## Process Change Notification

**Title:** MCC Introduces Auto-Soldering Process For DB-1&SDB-1 Package

**PCN#:** 080115-2

**Qualification Test Result:**

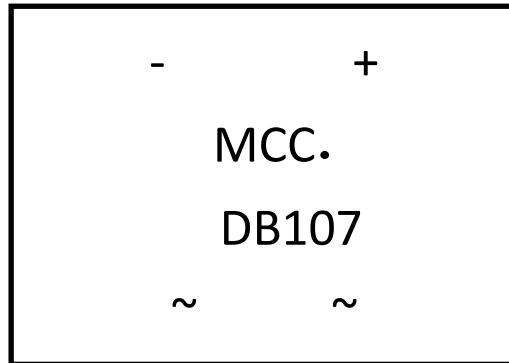
Devices were randomly selected by different power ratings.

Test	Condition	Interval	Results
HTRB	Ta=125°C, Rated Vr,	1000 Hrs	0/22
OP	Ta=25°C, Rated IF	1000 Hrs	0/22
PCT	Ta=121°C, 100%RH, 15psig	96 Hrs	0/22
TC	-55°C~+150°C	1000 Cycles	0/22
Resistance to solder heat	260°C for 10s		0/10
Solderability	245°C for 5s		0/10
